# CAUI-4 Ad hoc

Ryan Latchman, MACOM

# Agenda

Figure 83D–2—Typical CAUI-4 chip-to-chip application

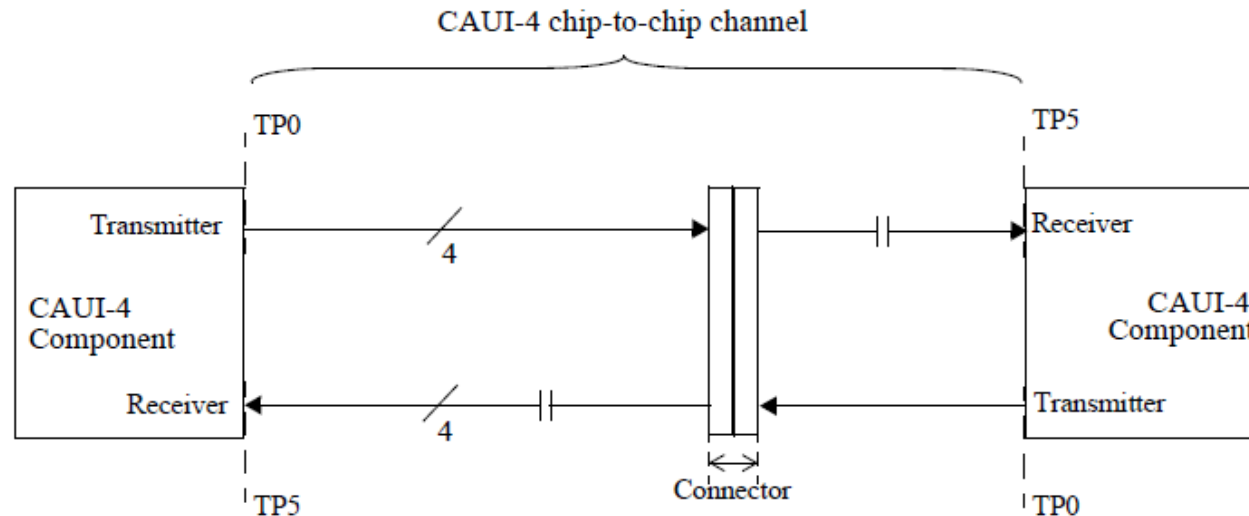
The CAUI-4 bidirectional link is described in terms of a CAUI-4 transmitter, a CAUI-4 channel, and a CAUI-4 receiver. Figure 83D–2 depicts a typical CAUI-4 application, and Equation (83D–1) (illustrated in Figure 83D–3) summarizes the informative differential insertion loss budget associated with the chip-to-chip application. The CAUI-4 chip-to-chip interface comprises independent data paths in each direction. Each data path contains four differential lanes which are AC coupled. The nominal signaling rate for each lane is 25.78125 GBd. The CAUI-4 transmitter on each end of the link is adjusted [to an appropriate setting](#) based on channel knowledge. [If implemented, the transmitter equalization feedback mechanism described in 83D.3.3.2 may be used to identify an approximate setting with the appropriate setting.](#) The adaptive or adjustable receiver [performing-performs](#) the remainder of the equalization. ~~Operation and control of this receiver is outside the scope of this standard.~~
